CITY OF PORT WENTWORTH

PLANNING COMMISSION

MARCH 14, 2022

Site Plan Review Application submitted by Paul Lerner for PIN #:7-0906-04-091 & 7-0906-04-063 (Mulberry Blvd Extension) for a Specific Development Site Plan to Extend Mulberry Blvd in a M-P-O (Master Plan Overlay) Zoning District.

SHEET
C1.2

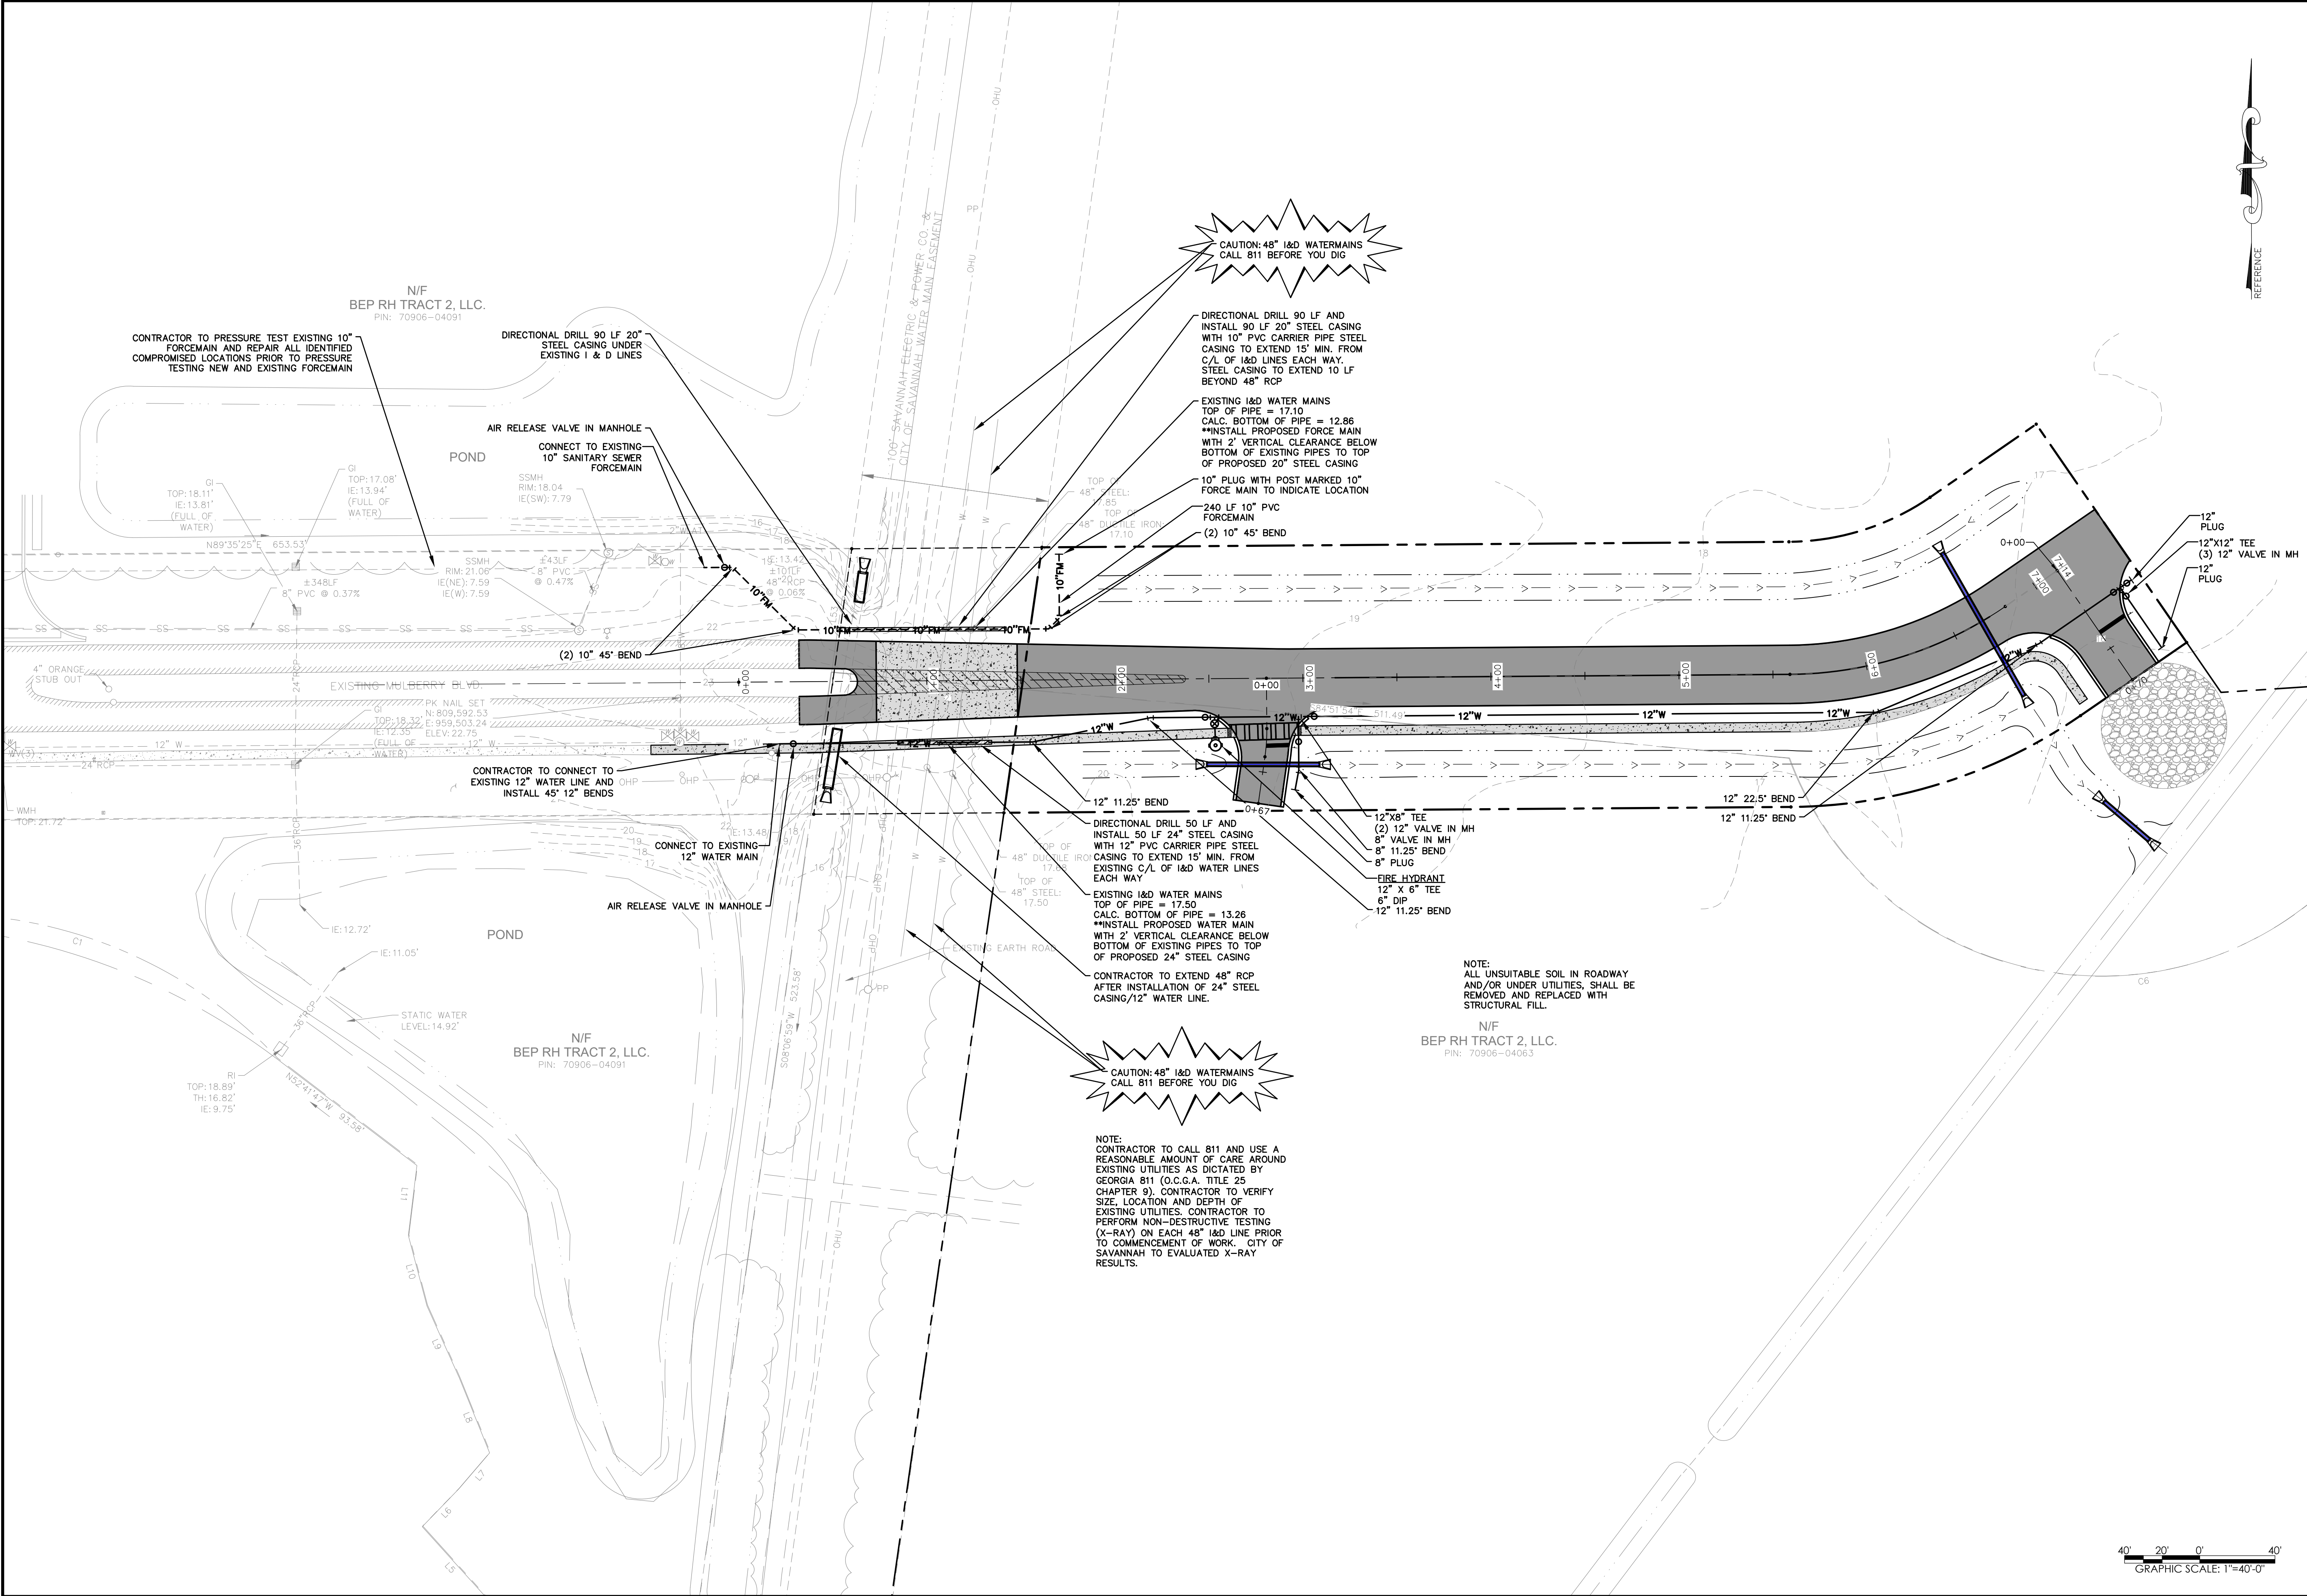
9. The plans show minimal striping and signage along the new roadway. Include in the plans the necessary striping, signage and traffic devises required.

12. The plans show a cross walk at the road intersection. Add handicap ramps where the sidewalk connects to the roadway. Also verify the crosswalk meets ADA requirements and does not exceed the required 2.0% cross slope.

The handicap ramps have been added to the sidewalk at the roadway connection. The sidewalk has also been revised to meet ADA requirements and does not exceed the cross slope of 2%.

SHEET
C2.1

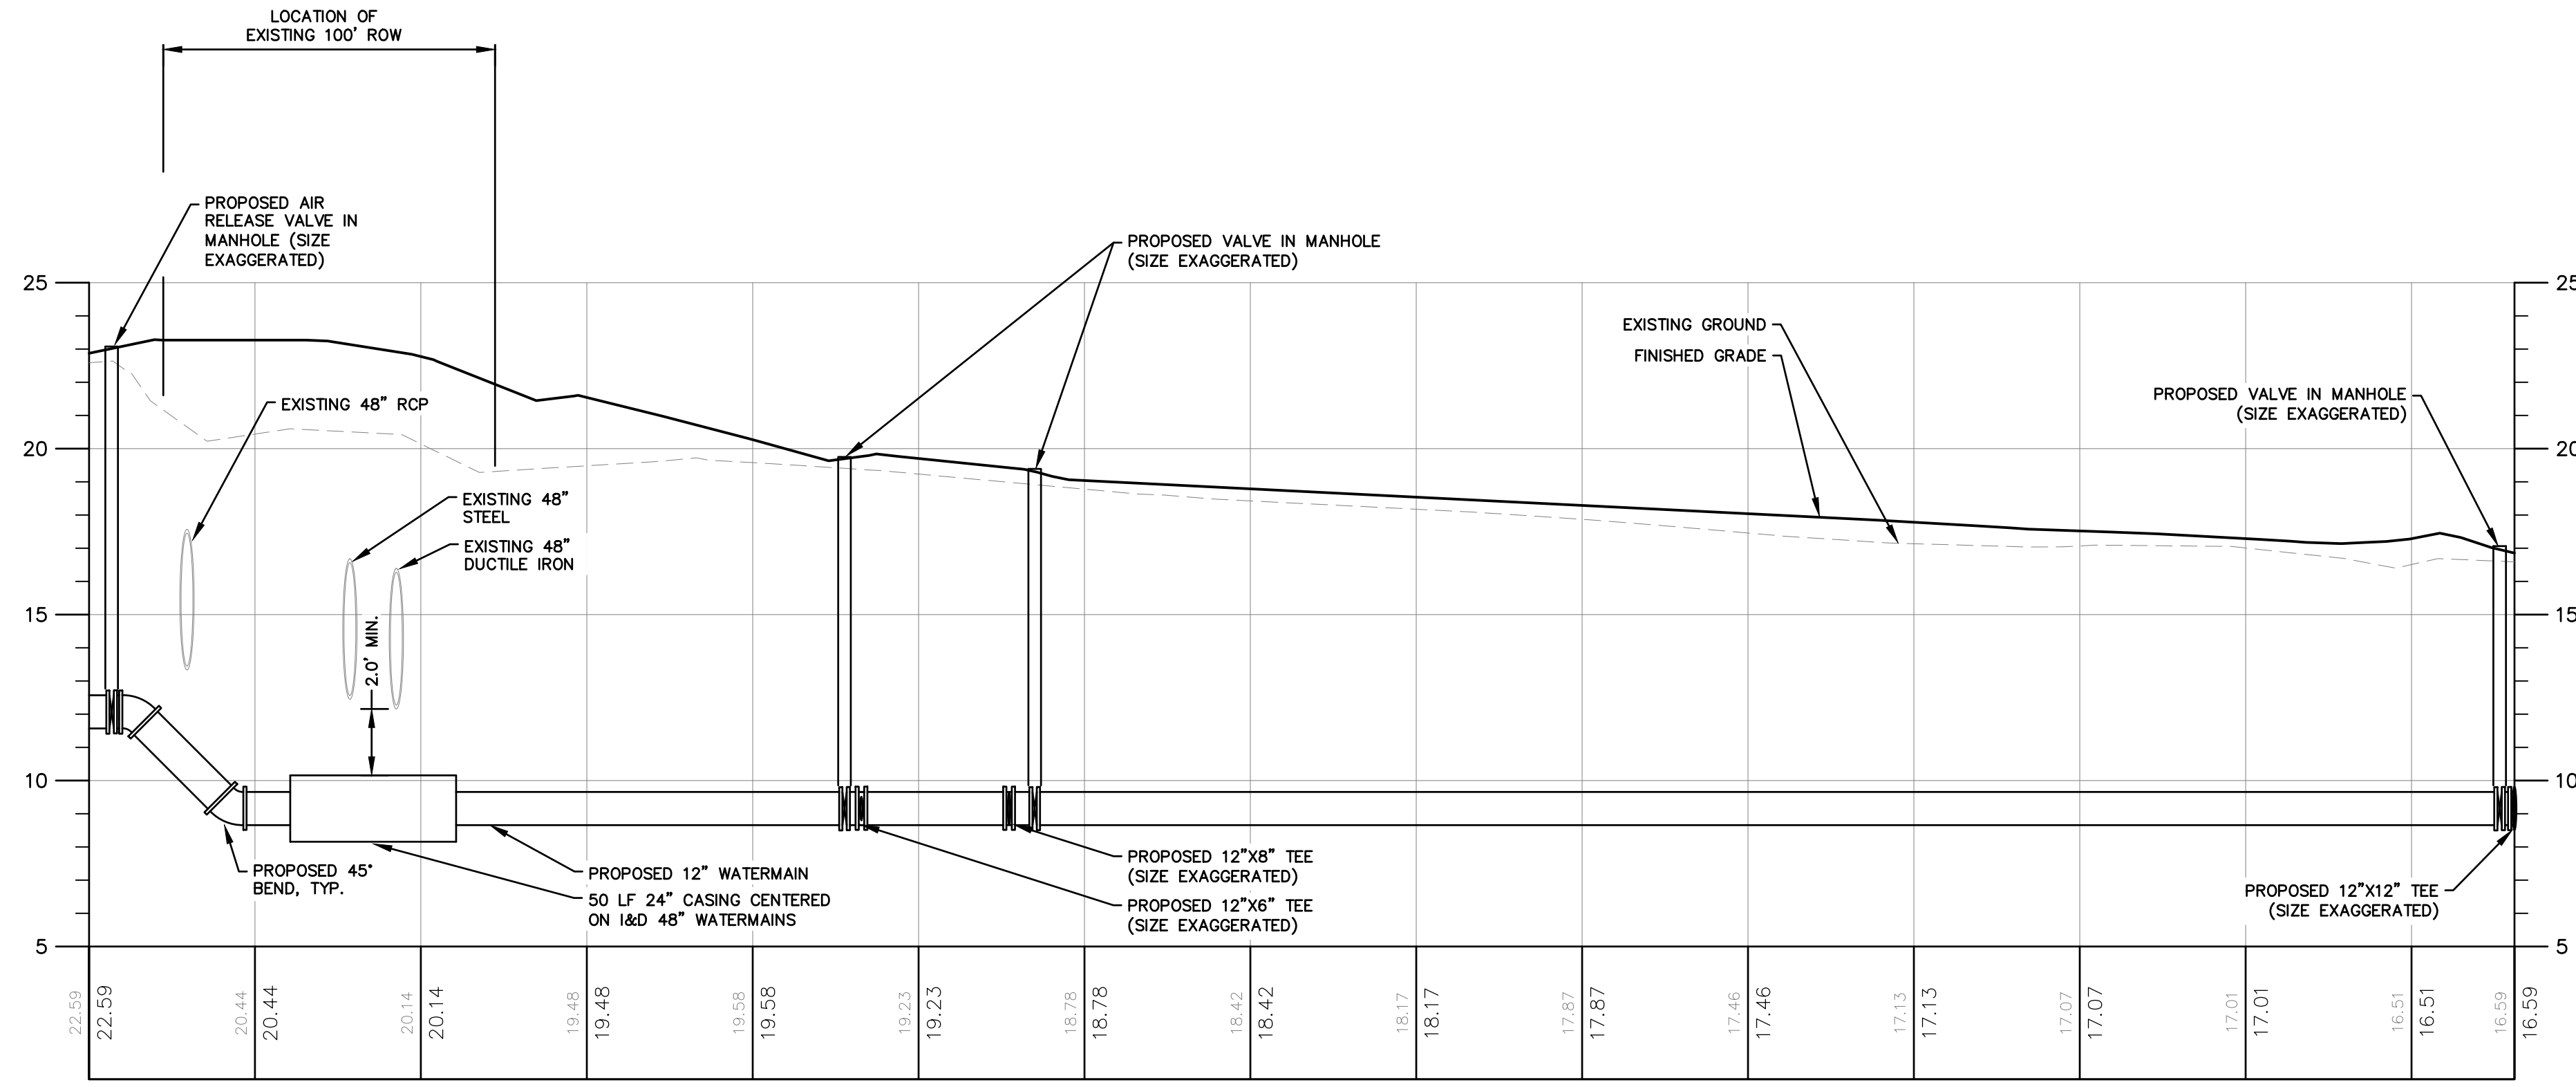
19. The new force main is showing ending near the new right-of-way line. Show the installation of a new cap or plug at the end of the line and a post to mark the location.

SHEET
C2.3

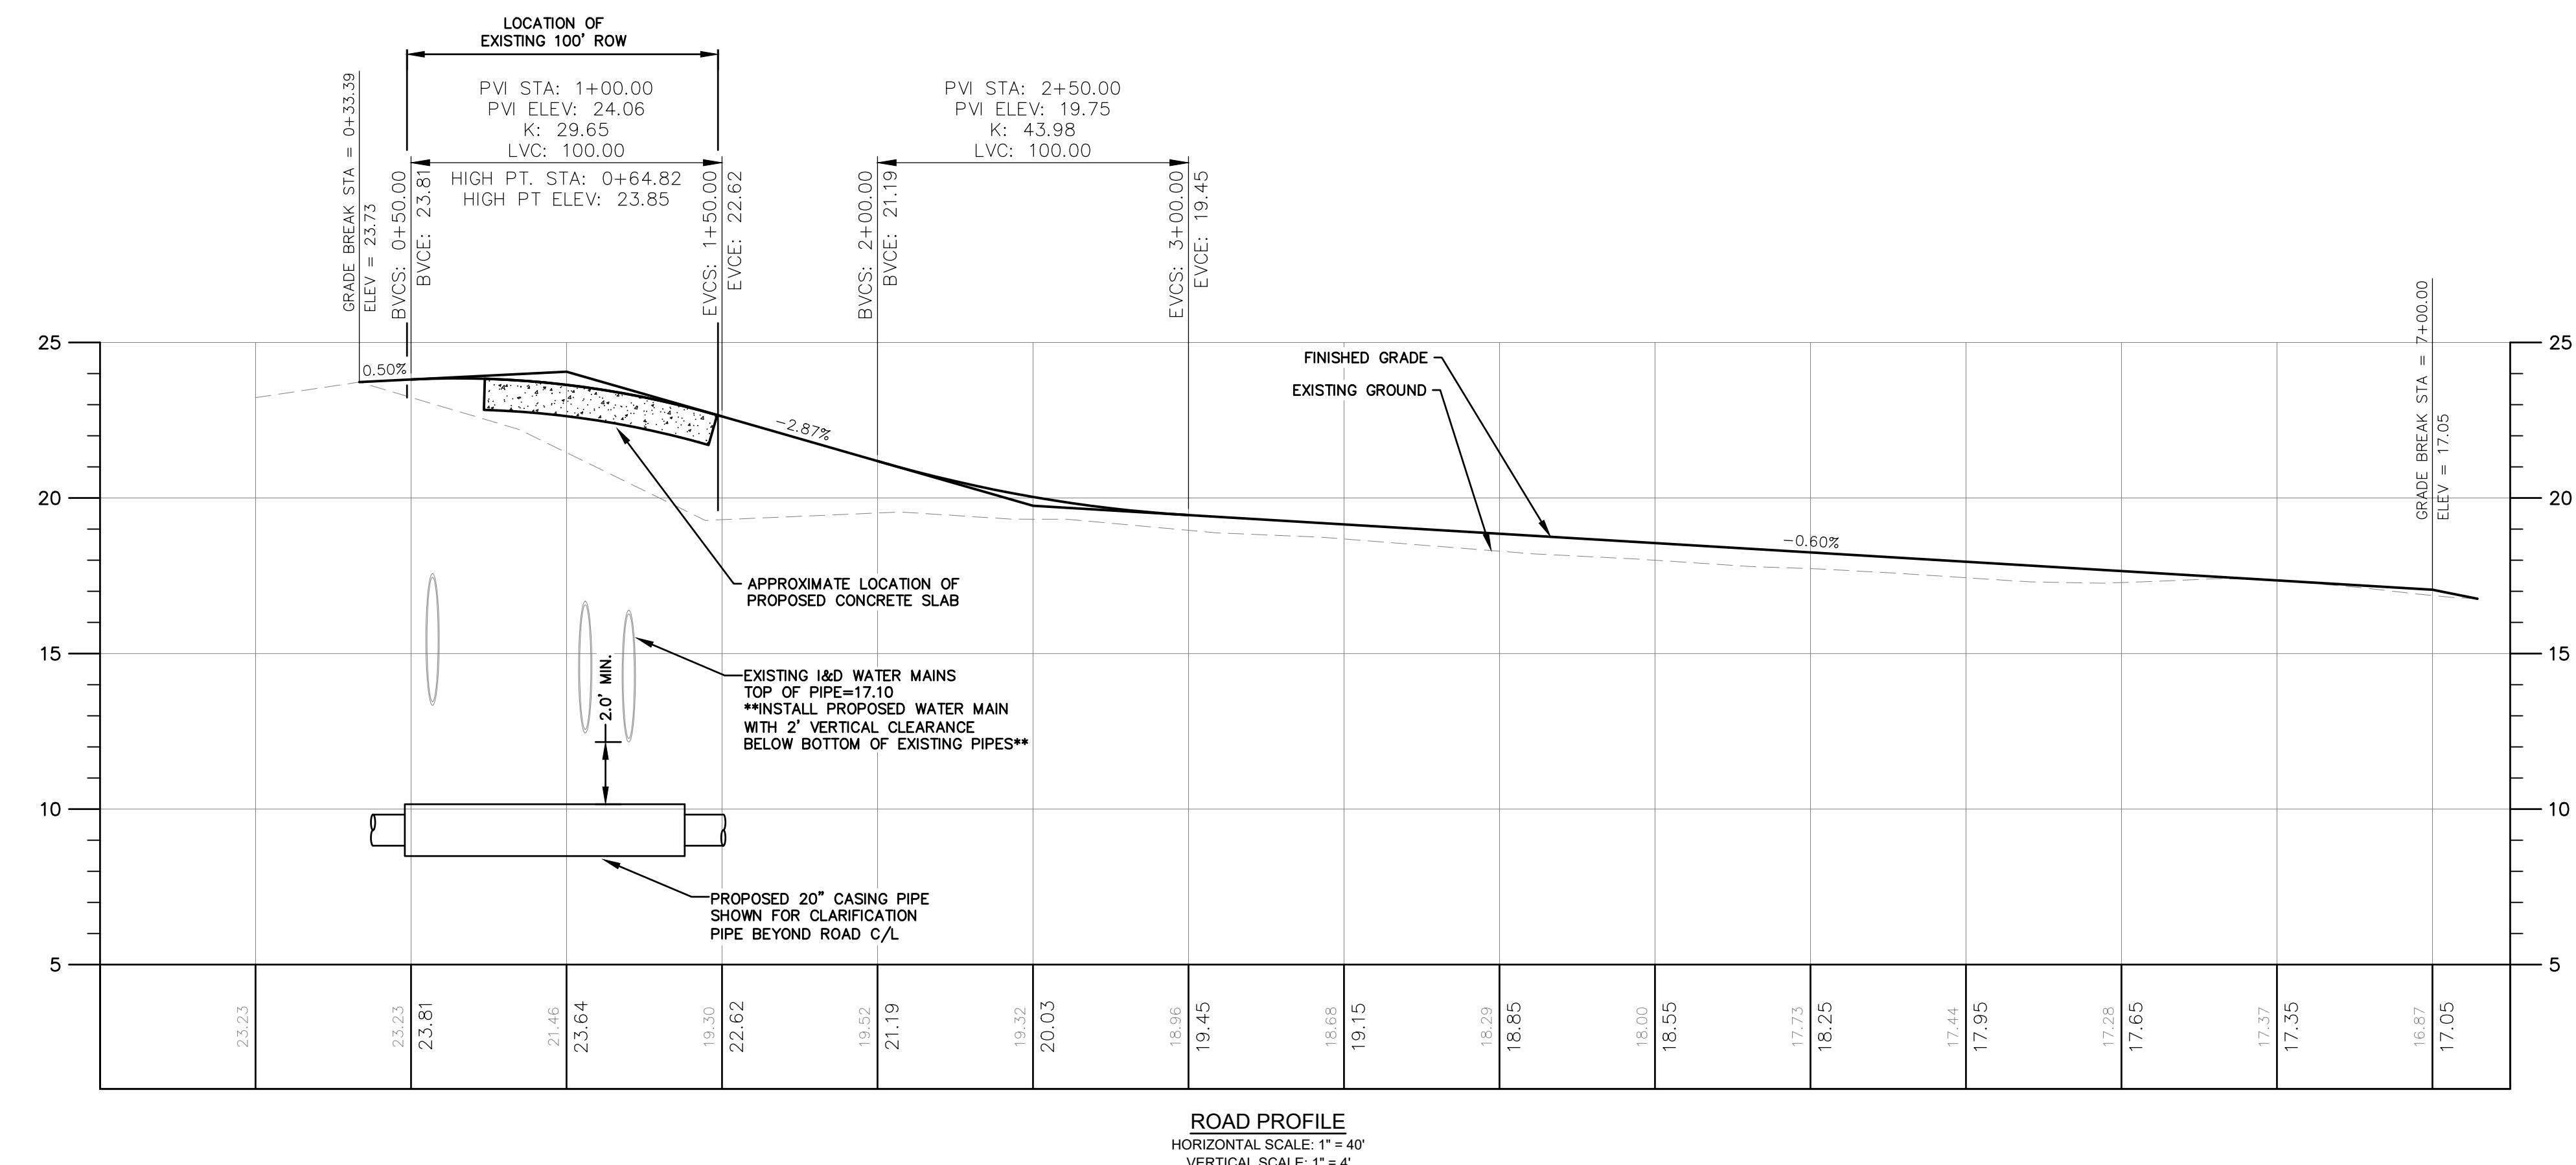
5. The roadway design starting at station 7+00 to the temporary cul-de-sac does not meet any design standard. (i.e., cul-de-sac) Please provide a masterplan for this area so that the termination type for this roadway can be evaluated. Roadways with a 90-degree bend as shown are not allowed. The minimum roadway radius in 150-feet.

6. The new roadway is being shown as 31' wide and the side roadway is being shown at 22' wide. Please provide reasoning for the 31' width of pavement. Also please provide justification for the roadway not being 24' in width.

14. Several of the storm pipes are shown as 15" diameter. The minimum pipe size allowed is 18" diameter. Additionally, provide storm calculations for all the pipe crossings.

15. Provide storm calculations for the existing 48" pipe crossing near station 0+50 to determine if the size is sufficient prior to constructing the new roadway. Additionally show providing end treatments for each end of the 48" pipe.

16. The storm pipes are shown with odd lengths. Lengths should match nominal pipe lengths for concrete pipe if possible.
17. No topographic information is shown for the near flared end section #2 to existing discharge ditch. Provide additional topographical data for this area.
